Amendments to the Drawings:

Applicant : Patrizio Vinciarelli
Serial No. : 10/802,379
Filed : March 17, 2004
Page : 5

Attorney's Docket No. 00614-136002

FIG. 8A

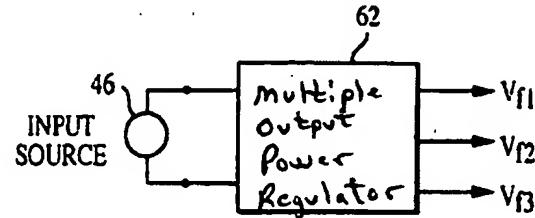
- (1) the "Front End Power Processor" label has been added to Box 22 in Fig. 2A;
- (2) the "Multiple Output Power Regulator" label has been added to Box 62 in Fig. 8A;
- (3) the "Power Converter" label has been added to Boxes 63a, 63b, and 63c in Fig. 8B;
- (4) the "Regulator" label has been added to Boxes 66a, 66b, and 66c in Fig. 8C; and
- (5) the "Rectifier and Conditioner" label has been added to Box 112 in Fig. 16.
